2018 - 2019 Cadillac ATS-V - CTS-V: Service Bulletin: #20-NA-054: Rear View Camera Guidance Lines Dim After Radio Replacement or Programming

#20-NA-054: Rear View Camera Guidance Lines Dim After Radio Replacement or Programming - (Mar 3, 2020)

Subject: Rear View Camera
Guidance Lines Dim
After Radio Replacement
or Programming

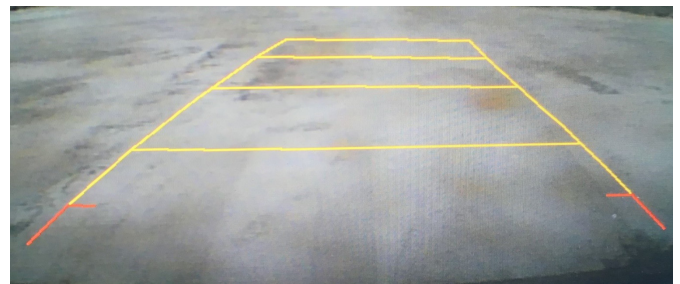
Some customers, after having radio replacement or radio reprogramming, may report that the Rear-View Camera (RVC) guidance lines are not as bold

as previously viewed, that they are faint, see-through, thinner, dim, or translucent; and they used to be more visible. A comparison between similar vehicle models may, or may not, show a difference in rear view camera guidance line appearance.

This may be caused by installing calibration files released in mid-2018 during radio replacement or reprogramming of the radio. The change to increase translucency was done to prevent the lines from

obstructing objects in the field-of-view.

Do not attempt repairs. The thinner, lighter appearance of RVC guidance lines is operating to design intent.
